SERVICE INFORMATION LETTER NO. SIL20A1-007

Replacement of oil dipstick.

INTRODUCTION OF A NEW OIL DIPSTICK FOR ROTAX® ENGINE TYPE 912 AND 914 (SERIES)

SB-912-040 R1

the following drawings should provide additional information:

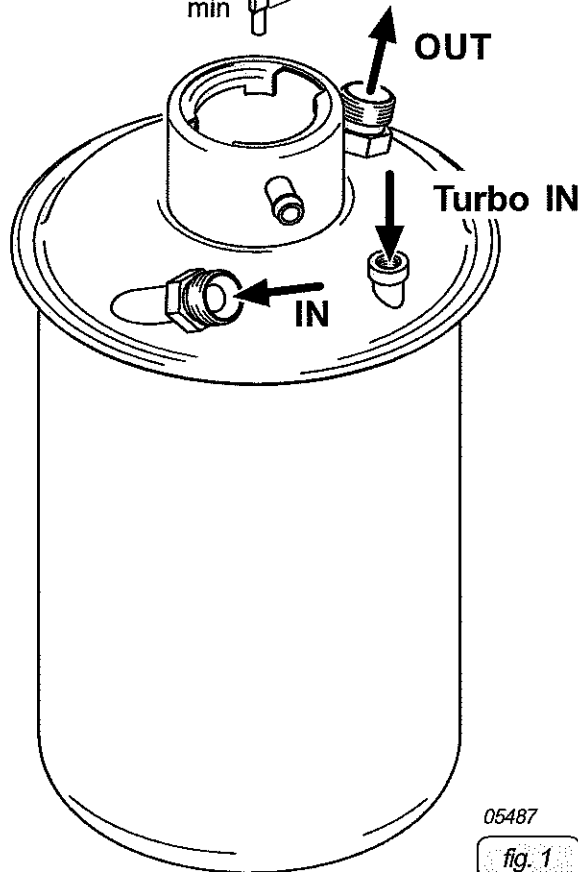
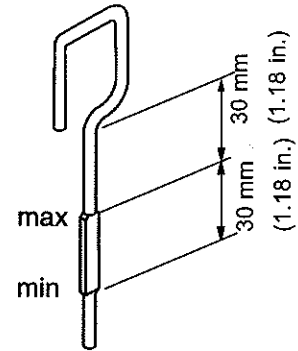
◆ **NOTE:** By changing the oil dipstick, the minimum oil level is raised by approx. 40 mm (1.57 in.) and the height between the "min." and "max." level is reduced to 30 mm (1.18 in.) (approx. 0,45 litre).

oil dipstick, old version

oil dipstick, new version

- Remove the oil dipstick part no. 956150 and replace by new oil dipstick part no. 956151.
- Inspect the oil level to be performed SI-27-1997 "Oil level check", current issue.
- Add oil if necessary.
